Re: G & H Landfill Comments on PRAP and RI/FS

**COMMENTS ON THE PROPOSED REMEDIAL
ACTION PLAN AND REMEDIAL INVESTIGATION/
FEASIBILITY STUDY**

**G & H Landfill Site
Shelby Township, Michigan**

**OCTOBER 1990
REF. NO. 1989 (11)**

figure 1
PROPOSED MODIFIED CAP DESIGN
G & H Landfill

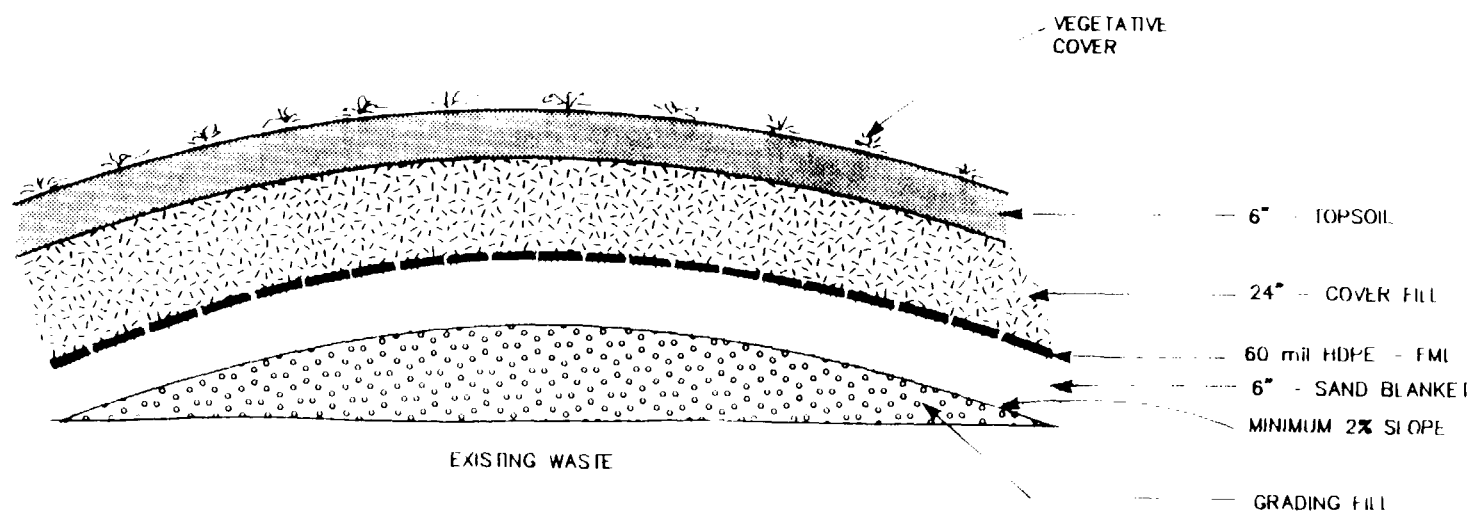
cap design has already been approved by MDNR at the Adrian Landfill located in southern Michigan. The FML would decrease the estimated infiltration rate of the three foot clay layer and thus provide better protection. A two and a half foot cover soil layer on top of the membrane will provide adequate protection to the FML from frost, burrowing animals and deep roots. Desiccation is not a concern with a FML cap. Periodic maintenance will also help to control animals and deep roots.

The FML cap design will eliminate the use of imported clay materials, thus solving problems associated with acquiring and transporting the clay. The substitution of a 60-mil FML for the three feet of clay and the reduction of cover soil from 3 1/2 feet to 2 1/2 feet would reduce the number of 20 cubic yard dump truck loads delivered to the Site by approximately 19,000 round trips. Figure 1 presents the proposed modified cap design. This cap design, including the FML and 2 1/2 feet of cover soil provides superior technical performance and has an estimated cost which is \$5,000,000 less than the PRAP preferred cap design. The membrane can be placed at a rate of one acre per day at an estimated cost of \$.50 per square foot.

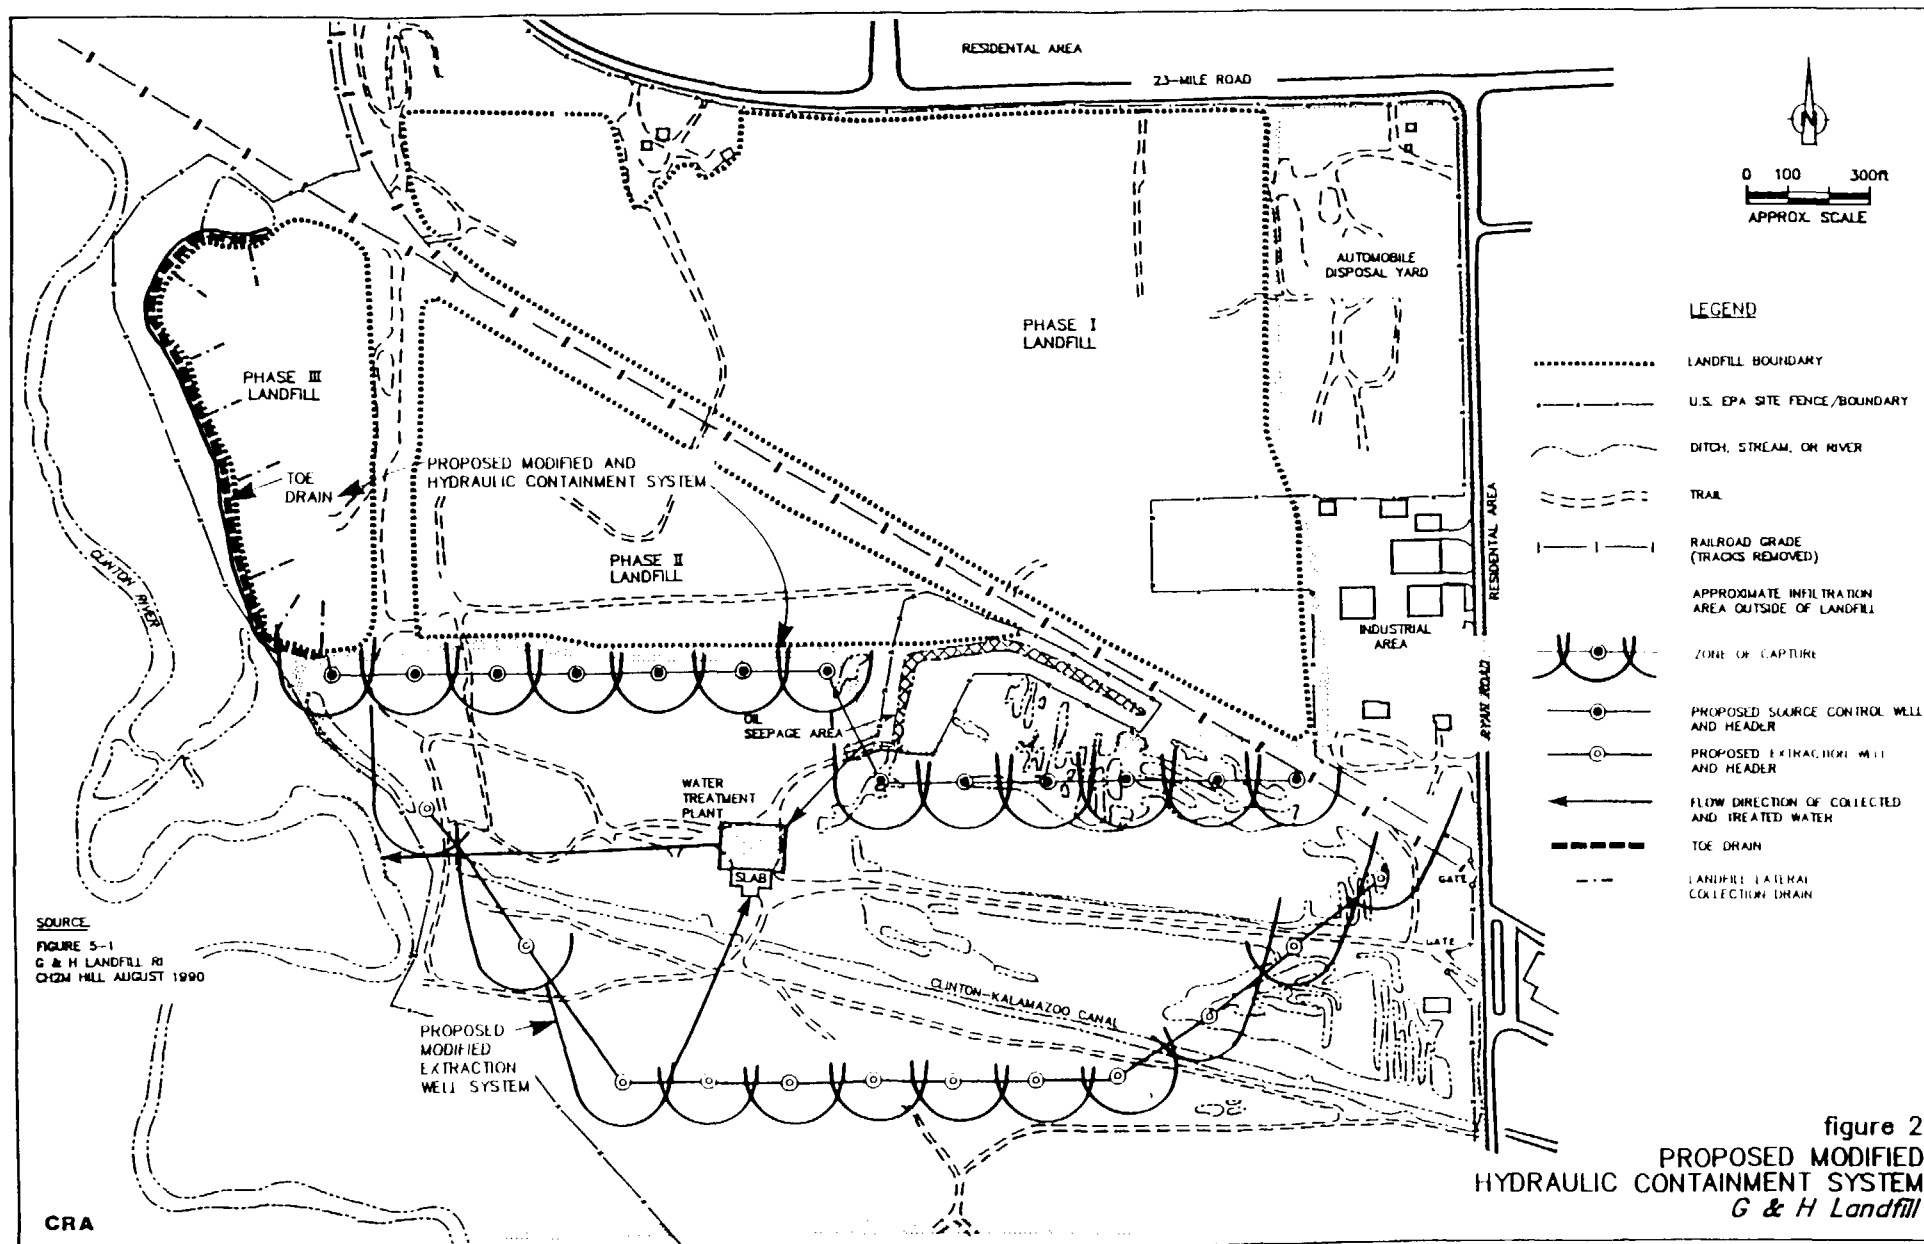
Physical containment using the slurry wall can be replaced by hydraulic containment to hydraulically isolate the landfill. The proposed

modified remedy consists of replacing the slurry wall and the 47 gradient control wells with 13 source control wells. Figure 2 presents the proposed modified hydraulic containment system. The 47 gradient control wells, in the PRAP preferred remedy, each one pumping at less than 1/4 gpm will cause frequent long term operation and maintenance problems due to insufficient flow velocities and the resultant fouling of pumps, screens and pipes. The 13 source control wells in the proposed modified remedy would each pump at 2 gpm reducing problems associated with extremely low flows. The reduced number of wells also reduces the amount of maintenance required. Operational problems associated with 47-1/4 gpm gradient control wells are presented in Section 2.2.2.

Therefore, the construction of the slurry wall and 47-1/4 gpm gradient control wells can be replaced with 13-2 gpm source control wells to provide hydraulic containment. The small reduction of groundwater to be removed and treated (5 percent) with the PRAP preferred remedy results in an increased capital cost of \$4,235,000 including contingencies and allowances.

in the proposed modified design. The total amount of groundwater that will be extracted with the proposed modified system is estimated to be 62 gpm. Figure 2 also presents the locations of the groundwater extraction wells.

figure 2.1
 PROPOSED MODIFIED CAP DESIGN
G & H Landfill

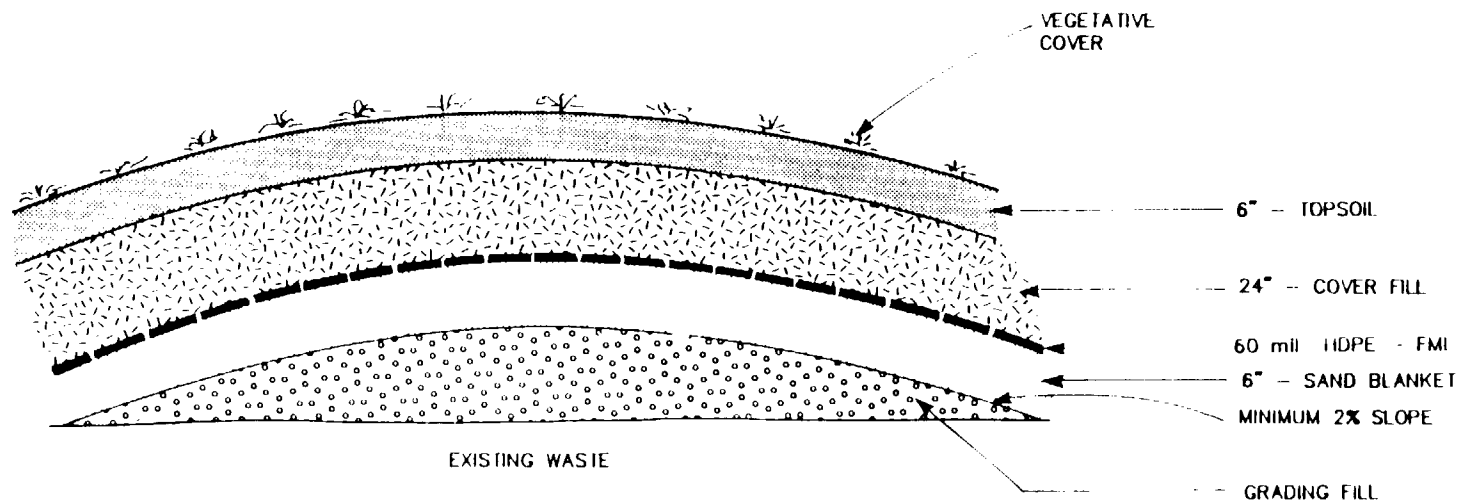
The PRAP preferred cap consists of 3 feet of clay and 3 1/2 feet of cover soil at a minimum 3% slope. The PRAP preferred cap can be optimized to provide superior technical performance and meet all remedial objectives in a much more cost effective way. Figure 2.1 presents a schematic of the proposed modified cap design.

A 60 mil high density polyethylene (HDPE) flexible membrane liner (FML) may be effectively substituted for the specified 3 feet of 10^{-7} cm/sec clay as the 60 mil HDPE FML, with appropriate bedding and cover soils, provides superior technical performance. The 60 mil HDPE FML has a permeability of 4×10^{-13} cm/sec which is 6 orders of magnitude less permeable than 1×10^{-7} cm/sec clay. In other words, under a unit gradient, the travel time of water through the 60 mil HDPE FML would be the same as the travel time through over 1,100 feet of 1×10^{-7} cm/sec clay.

The PRAP preferred cap consists of 3 1/2 feet of cover soil over the clay barrier layer. The purpose of the 3 1/2 feet of cover soil is to provide frost protection to the clay layer and to protect the clay against damage from desiccation, burrowing animals and deep roots. In this area of Michigan the required depth of frost protection is 2 1/2 feet as presented in the U.S. EPA guidance document "Final Cover on Hazardous Waste Landfills and Surface Impoundments" (EPA/530-SW-89-047, July 1989). Thus, the 3 1/2 feet of cover soil specified for the selected cap is not required for frost

protection. A reduction of the cover soil by 12 inches will not result in damage by animals or deep roots. Desiccation is not a concern with the FML cap. Animals and deep roots will be controlled as part of the periodic maintenance that will take place for the cap.

figure 2.3
WATER BALANCE
CRA ESTIMATE FOR CURRENT CONDITIONS
G & H Landfill

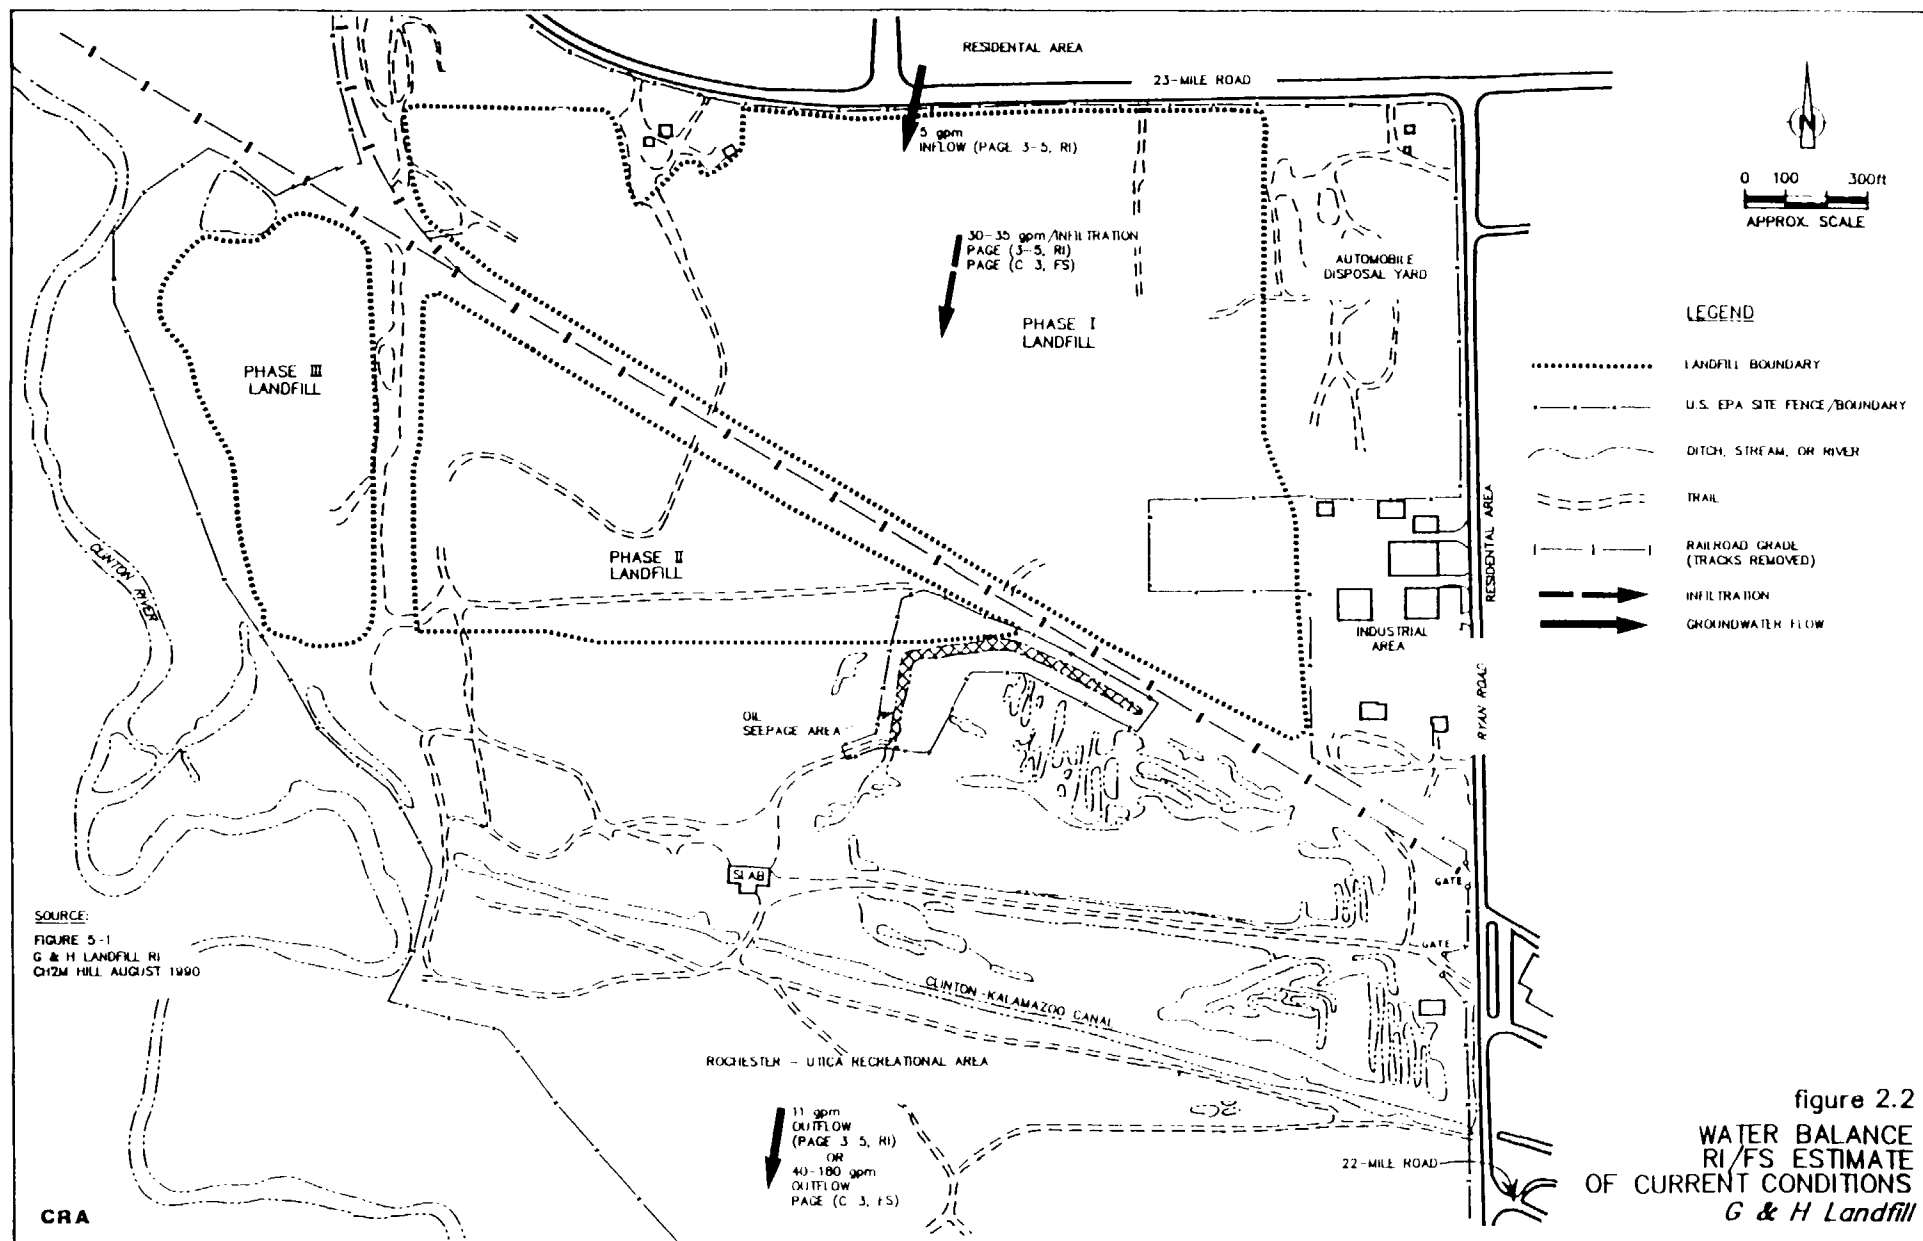
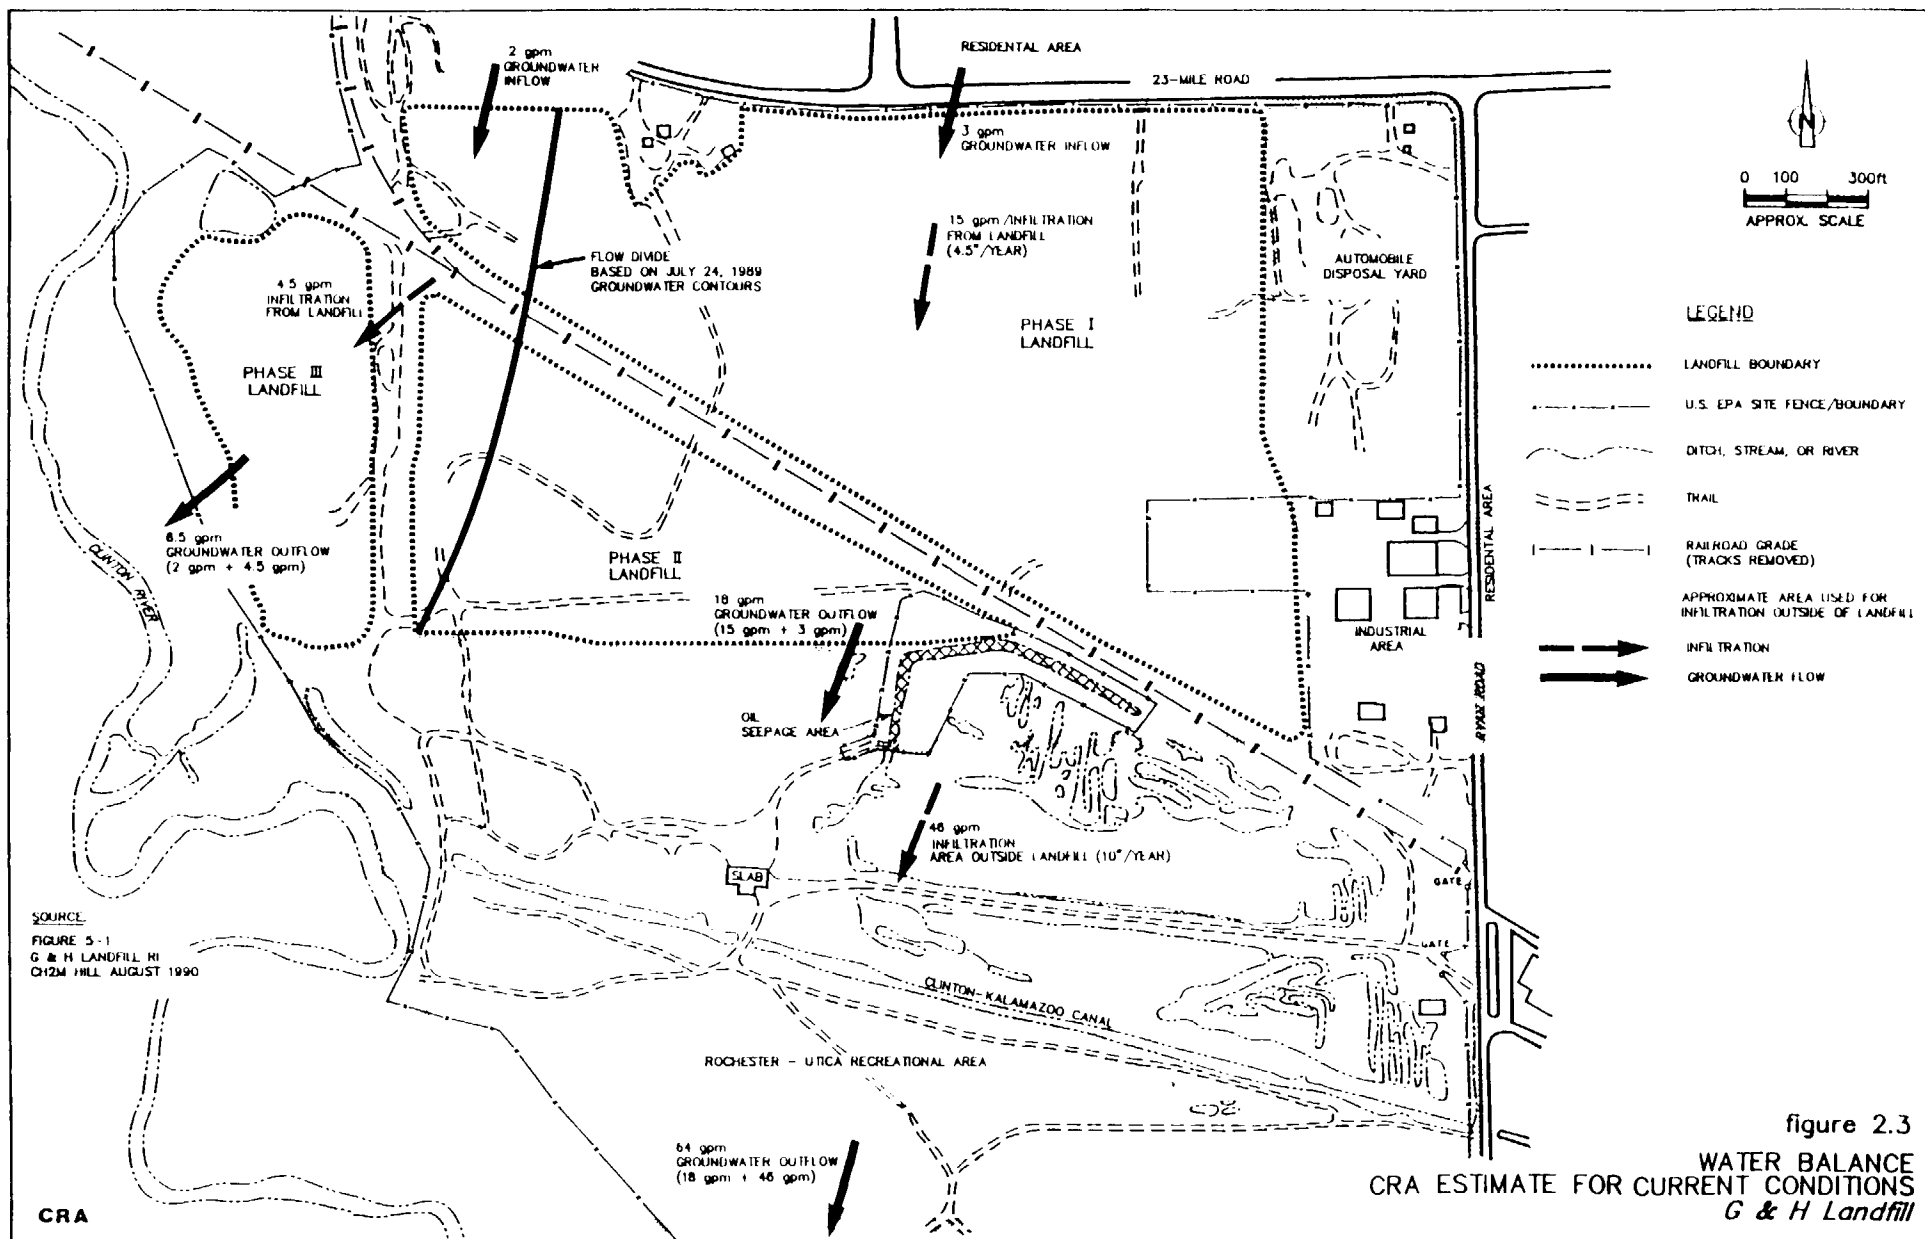
To properly evaluate the need for and performance of a vertical barrier slurry wall it is necessary to consider a water balance for the whole site. Figure 2.2 presents a summary of water balances from various sections in the RI/FS. There are many inconsistencies in these water balances. A water balance for current site conditions which is more realistic is presented by CRA on Figure 2.3.
